PRE-HEARING
GROUND WATER DISCHARGE PLAN ANALYSIS

MT. TAYLOR URANIUM MILL PROJECT
GULF MINERAL RESOURCES COMPANY

Ground Water Section
Water Pollution Control Bureau
New Mexico Environmental Improvement Division

September, 1980

FIGURE 3
MILL PLOT PLAN

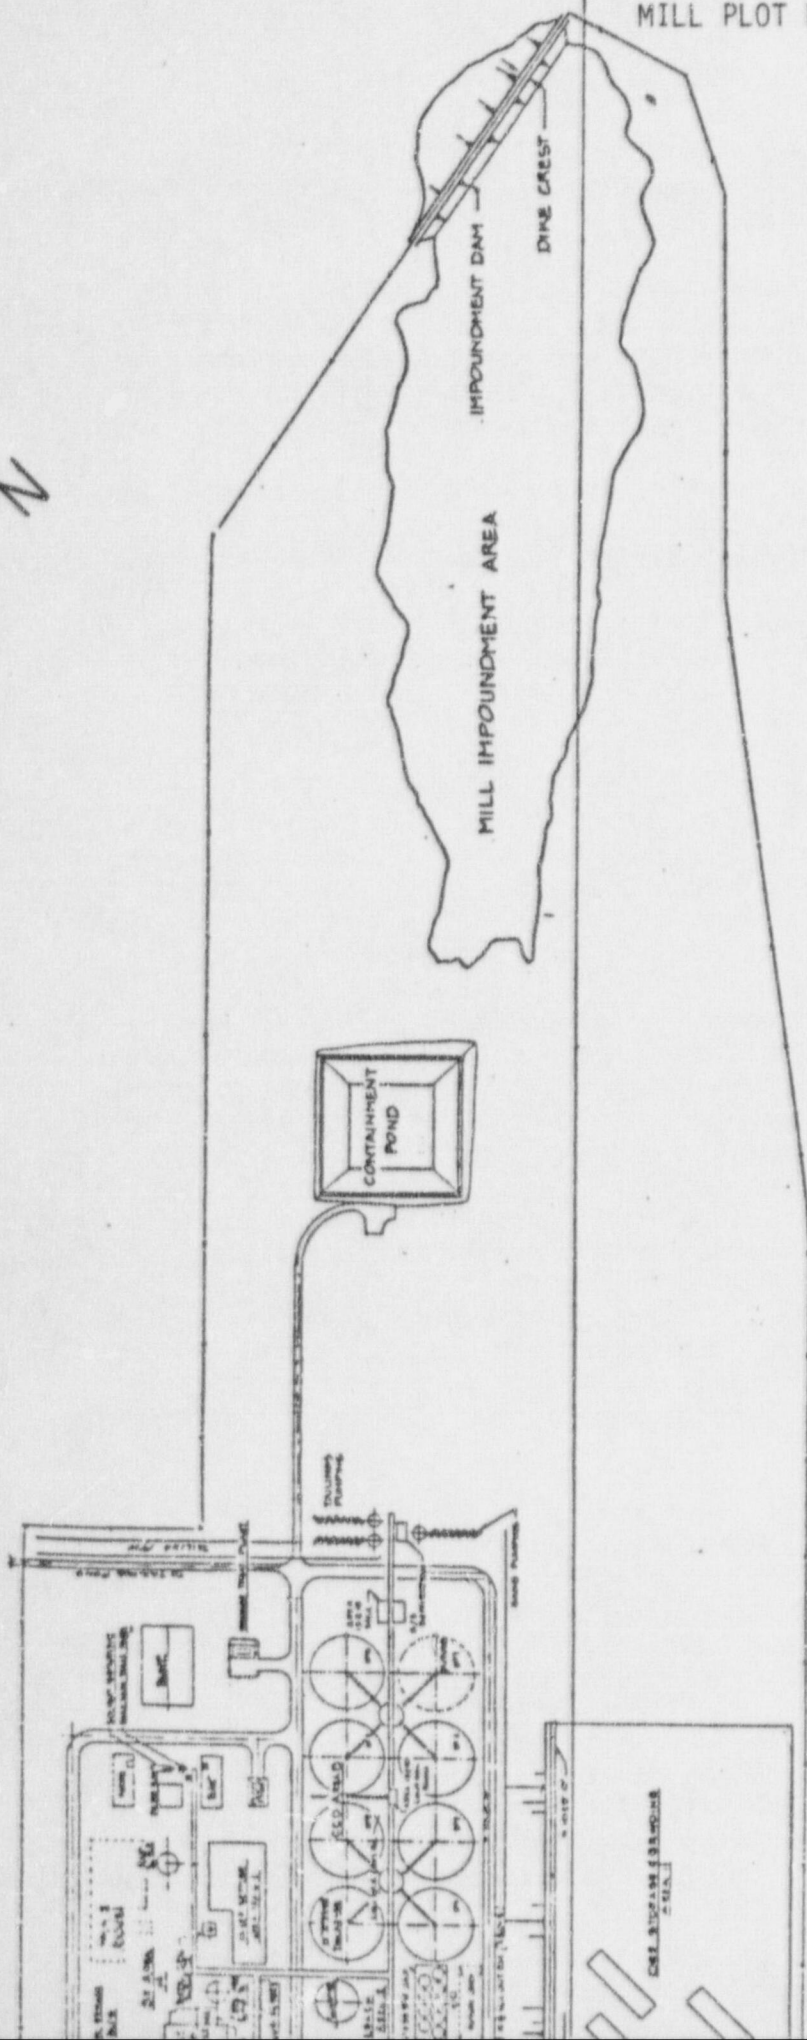
Our analysis of the site's geology and hydrology and of the engineering concepts and designs incorporated into the containment pond and mill impoundment generally supports Gulf's conclusion that minimal impacts to ground water should result from these structures. This is based upon the following key factors:

1. Planned discharges at the mill site, e.g., process area washdown water and sewage water, will be relatively low in volume. Except during periods of extraordinary precipitation, sufficient freeboard should exist in the containment pond to contain any major process spillage. Contaminated releases to the mill impoundment area, therefore, are seen to be infrequent.

2. The containment basin is proposed to be lined with 20 mil PVC plus 12 inches of earth and basin so that migration of liquid from the pond into the underlying strata will be minimized. The PVC is chemically compatible with the acidic mill waste, while the earth cover will greatly reduce ozone and ultraviolet radiation weathering effects on the lining.

FIGURE 5
TAILINGS PIPELINE CROSS SECTION

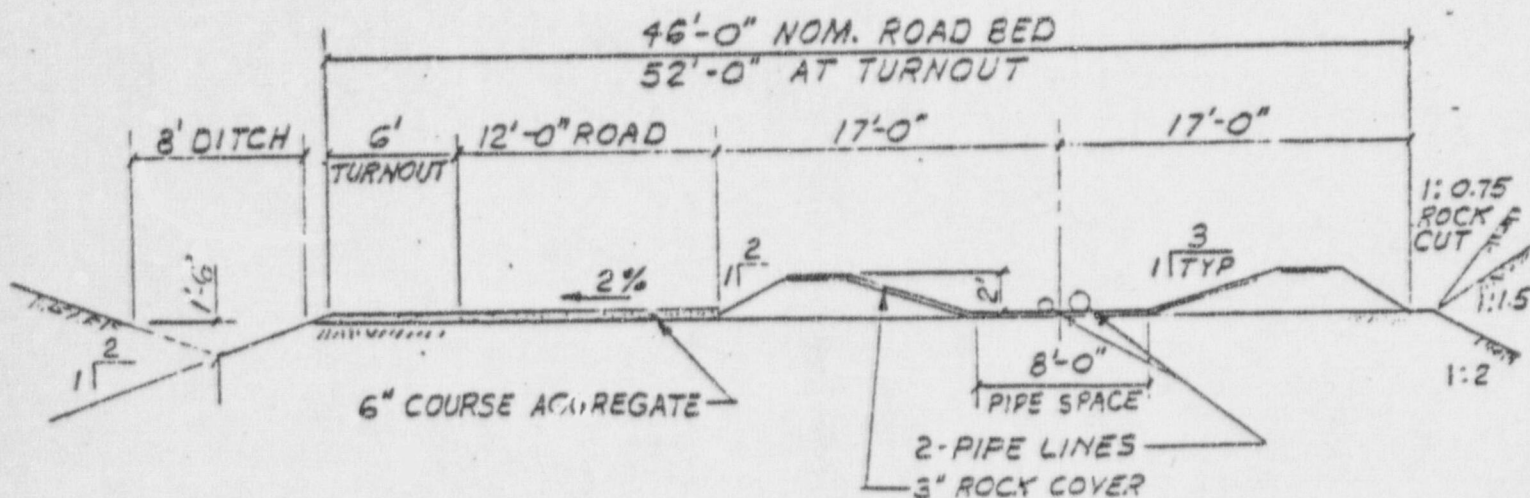
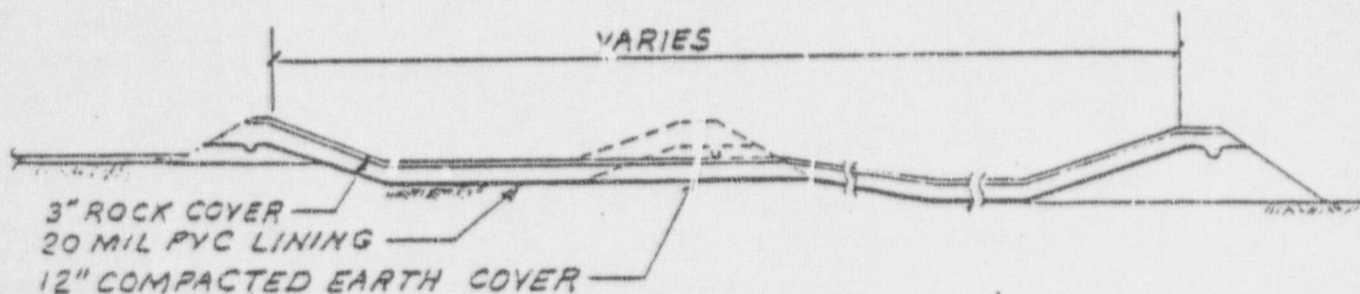
In summary, it is our opinion that the applicant's proposed pipeline system design is acceptable. It is believed that the redundant instrumentation and frequent inspection schedules will virtually eliminate any possibility of accidental spills adversely affecting ground water quality. Assuming a major release of tailings via pipeline rupture, it is unlikely that ground water standards would be violated at a place of foreseeable use.

FIGURE 12

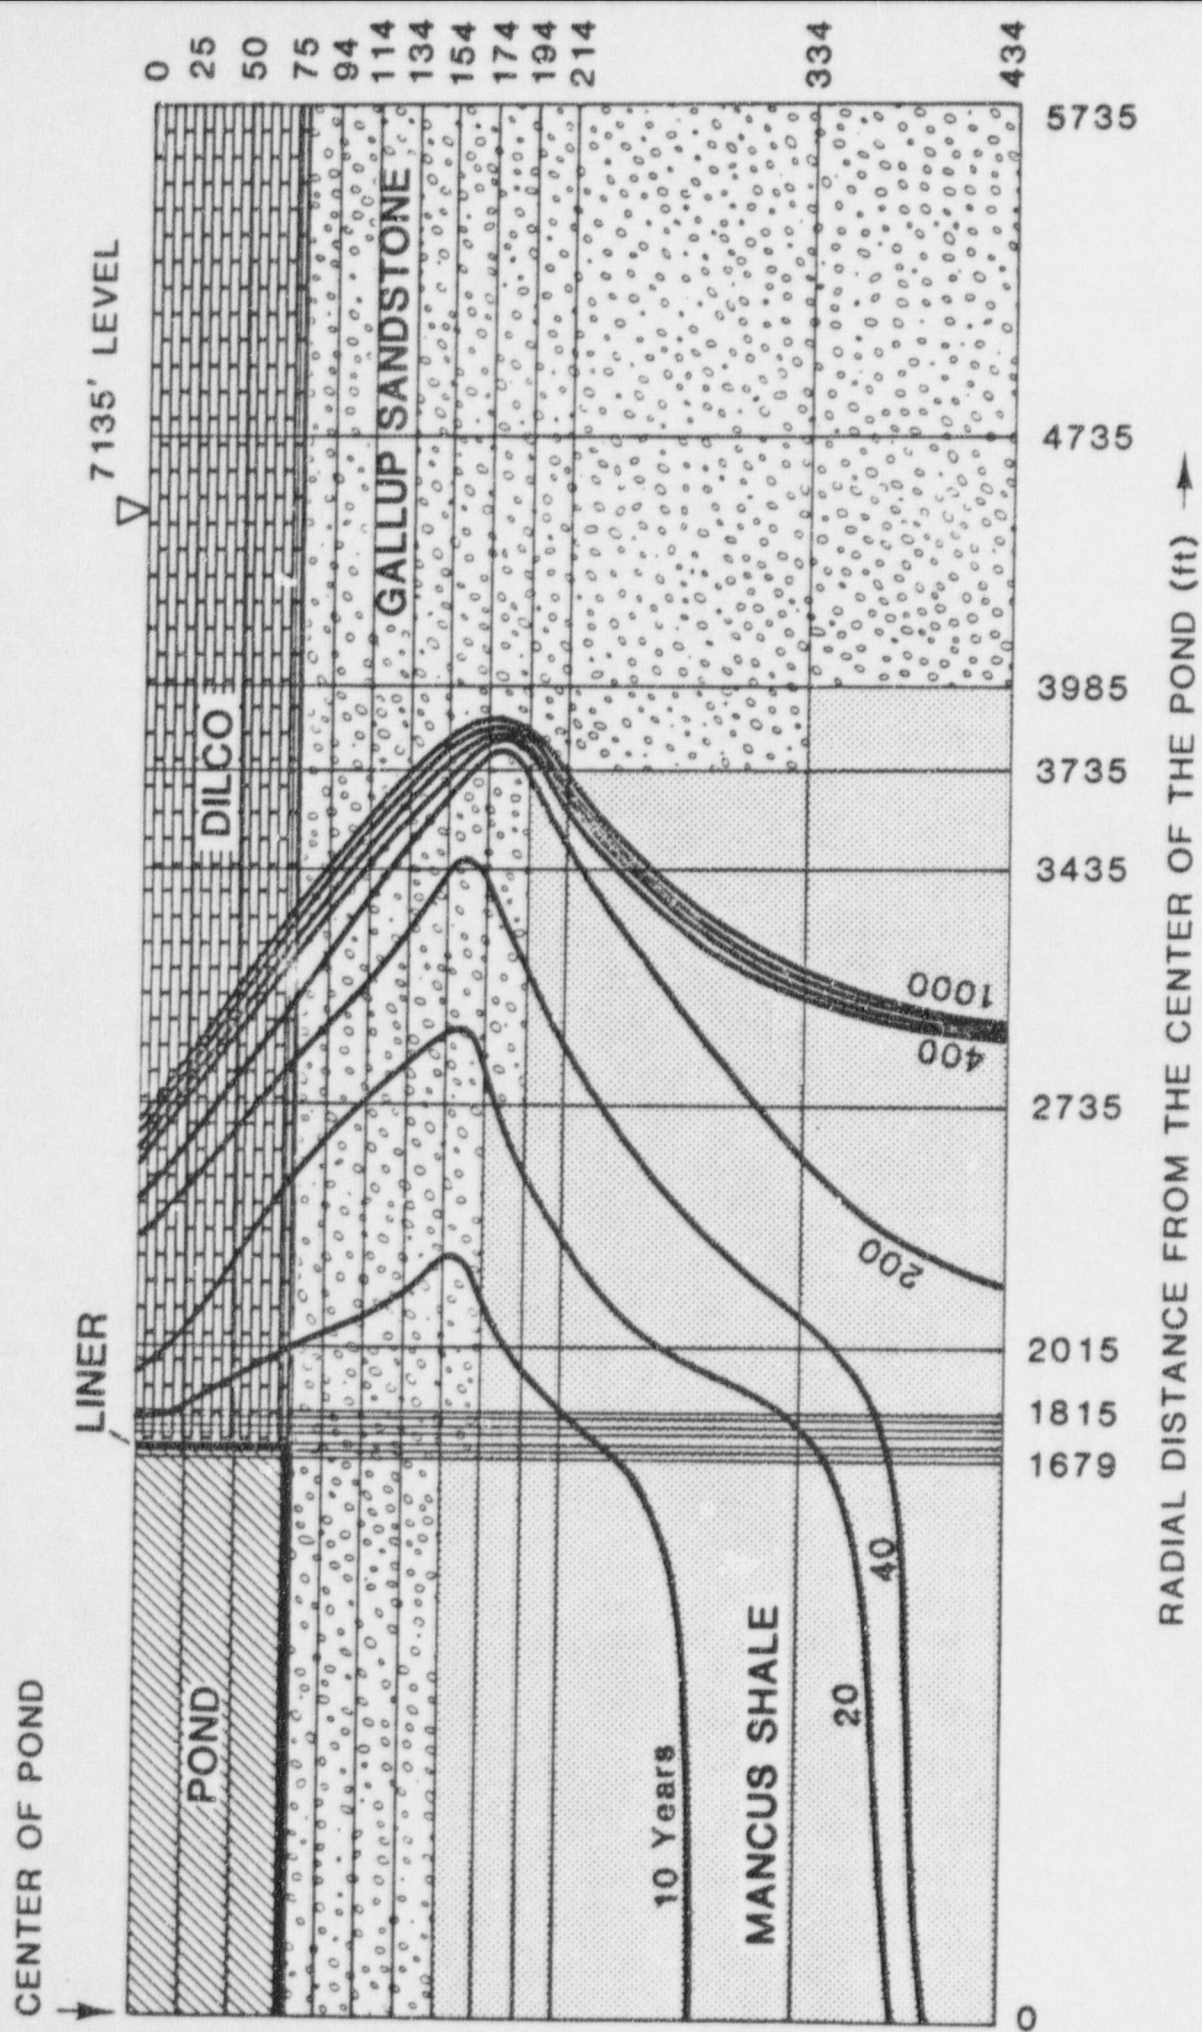
Our review of the initial simulation raised questions regarding the mesh size chosen, and regarding the dimensions of the cross-section chosen for discretization. Our particular concerns were:

The accuracy of the model is judged to be sufficient, given the revised grid mesh.

FIGURE 13

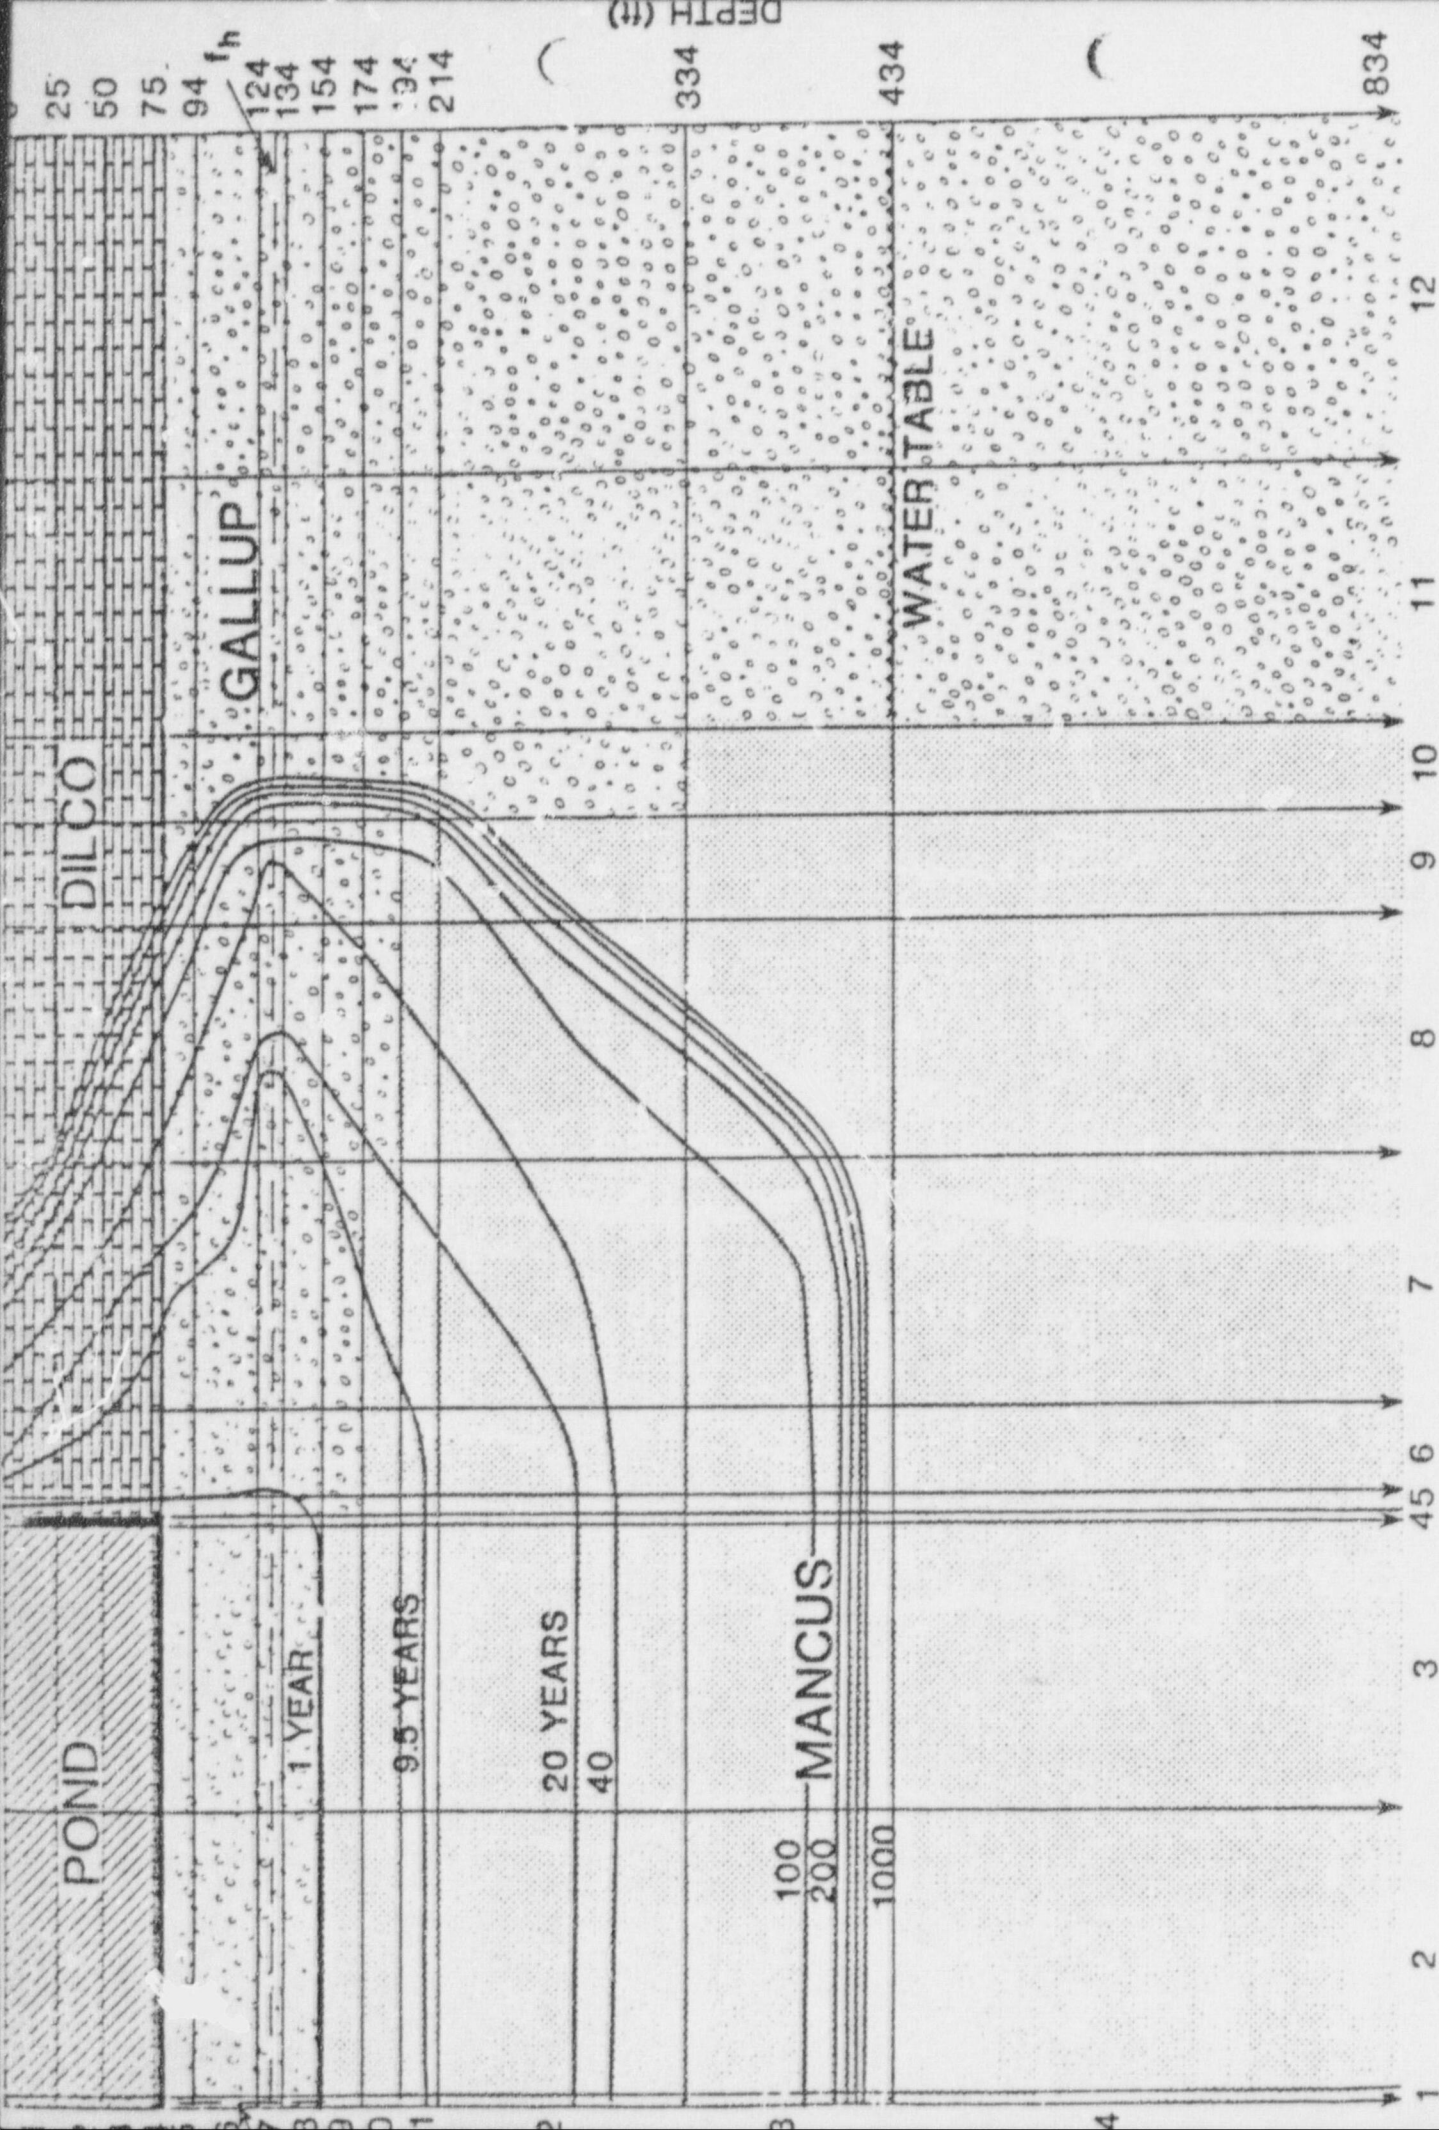
homogeneous, isotropic porous media. A major deficiency in the applicant's discharge plan and initial seepage simulation is the lack of information on fracture location, density, or related hydraulic conductivities.
